FINAL ENVIRONMENTAL IMPACT REPORT

SPAULDING REHABILITATION HOSPITAL
BUILDING ADDITION
AND
THERAPEUTIC/RECREATIONAL PIER

FINAL ENVIRONMENTAL IMPACT REPORT
EOEA NO. 7317

June 15, 1989

FIGURE 3-4
PROPOSED RECREATIONAL PIER

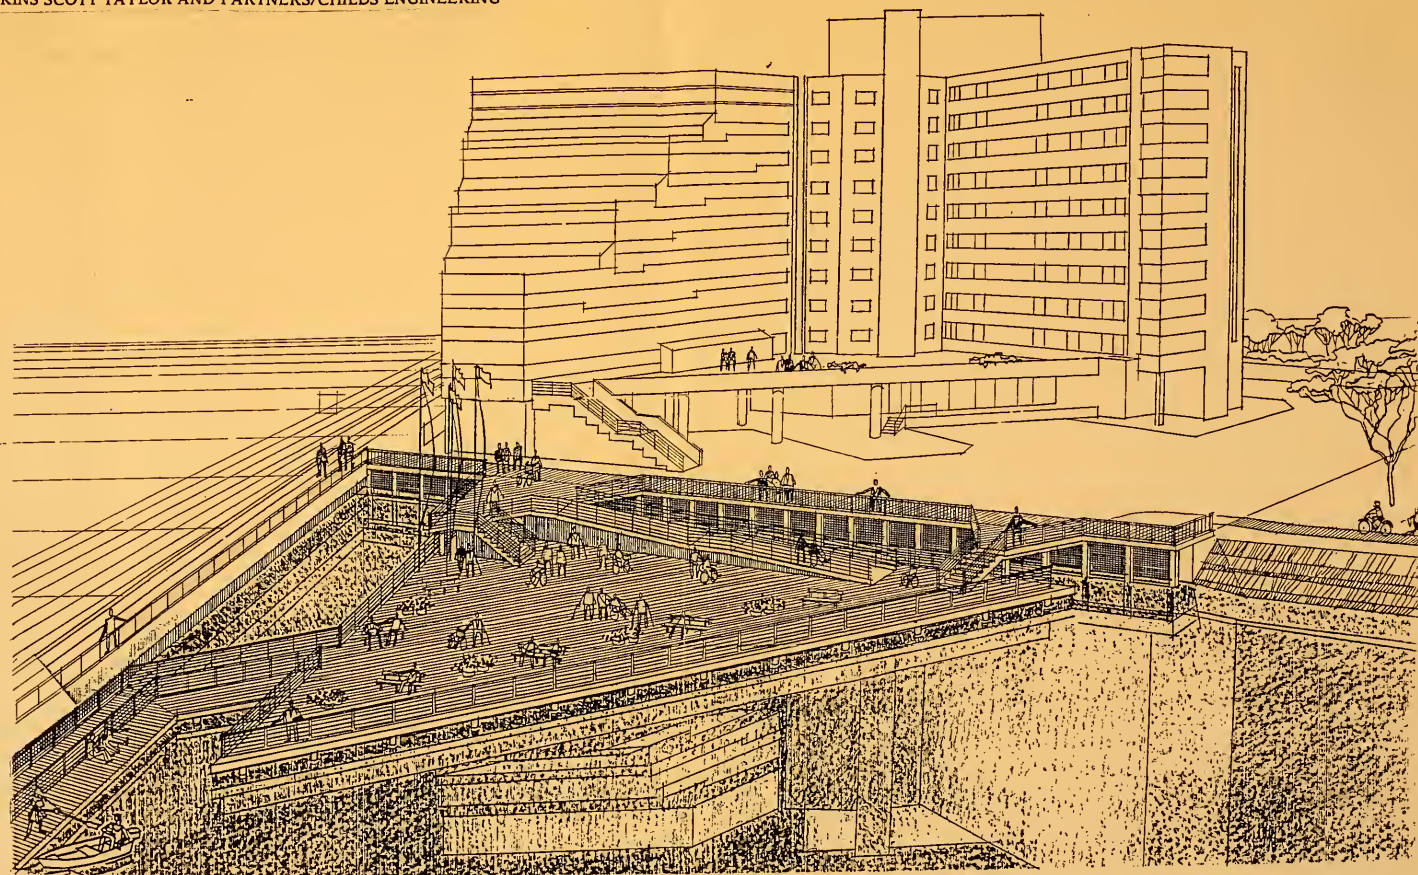
Comment #5.02 – Drawings

There needs to be further discussion between the MDC, DEQE, and hospital officials concerning final design of the pier as agreed to by all parties. The proponent should provide necessary drawings.

Perspective and plan drawings of the proposed pier have been prepared by HST and Partners architects with Childs Engineering. These are shown in Figures 3-3 and 3-4.

FIGURE 3-5
SITE PLAN OF PROPOSED RECREATIONAL PIER

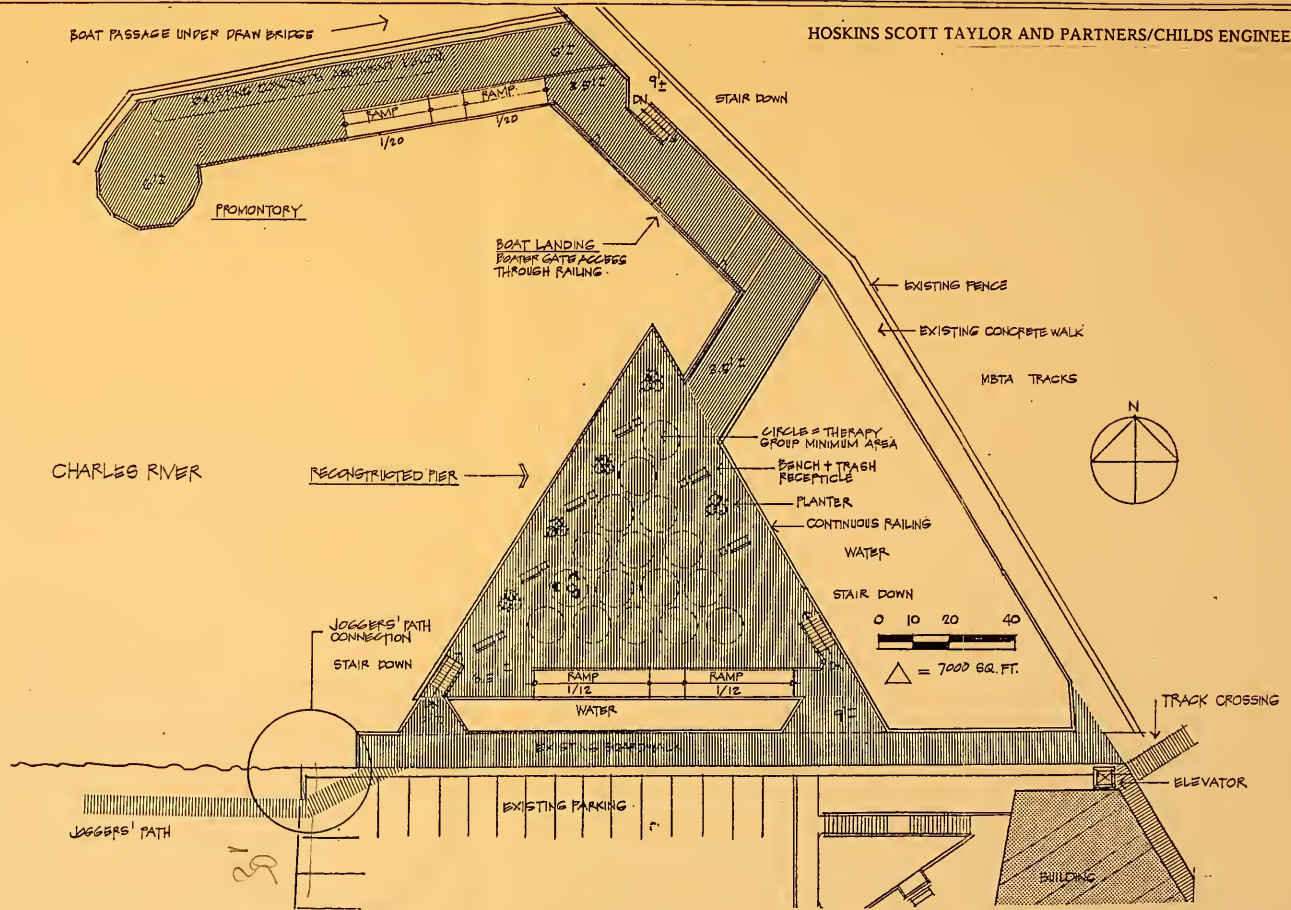
Comment #2.03 - Transient Boat Dockage and Fishing

Comment #4.04 – Boat Landing

Uses of the proposed recreational pier have been expanded to include transient docking for canoes and other small boats. This landing will be provided along the 3.5-foot walkway to the promontory, as shown in Figure 3-5. This will maintain the western edge of the pier for fishing and viewing. Ladders will be provided to facilitate boater access to

Uses of the proposed recreational pier have been expanded to include transient docking for canoes and other small boats. This landing will be provided along the 3.5-foot walkway to the promontory, as shown in Figure 3-5. This will maintain the western edge

FIGURE 3-7
PEDESTRIAN ACCESS - OPTION 1
CROSS-SECTIONS OF LANDSCAPING DETAIL

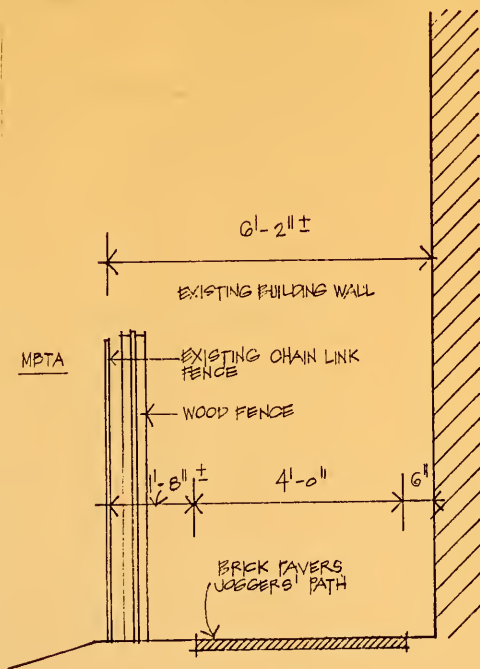
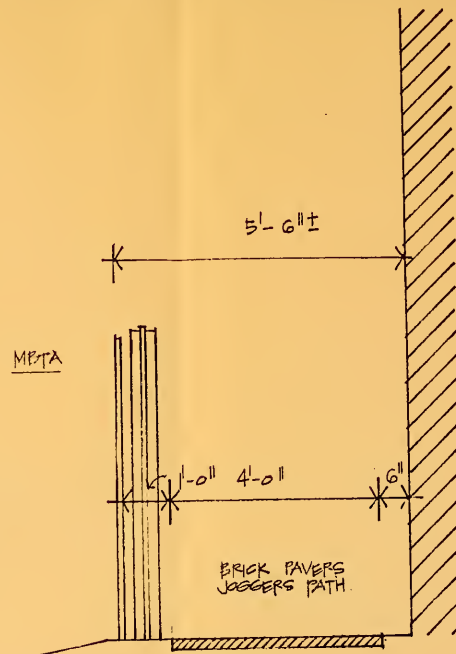
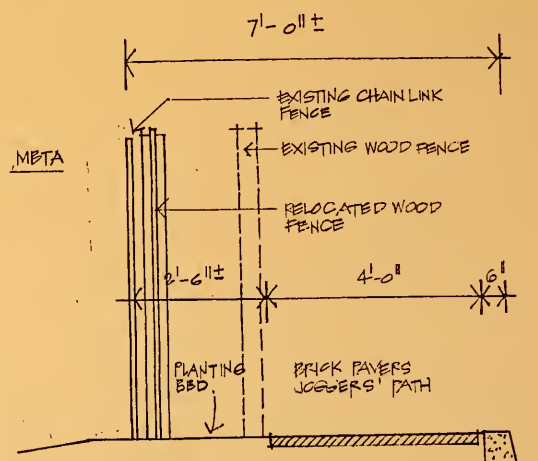
Comment #6.03 – Alternative Pedestrian Access Design

.03 The proposed harborwalk connections are consistent with the BRA's North Station Master Plan. The proposed pedestrian connection to the North Station area provides for a potential link across the MBTA tracks to the MDC Locks, thereby extending the Harborwalk system further along the Charles River Basin. However, we propose an option different than those presented in the DEIR for this connection. Our recommendation is that the walkway be extended along the western boundary of the hospital, along the MBTA tracks until the oxygen tank. We feel that this alternative would provide pedestrians a more direct, safe, and pleasant route to the North Station area as opposed to a route which follows under the building and across the parking lot. The Final EIR should include an examination of this alternative connection.

SRH has explored the pedestrian walkway suggested by the BRA and agrees that it is the most direct, safe, and pleasant route to the North Station area. The advantages of this alternative, described as Option 1 in this Final EIR, are discussed and illustrated in detail in Section 3.6.
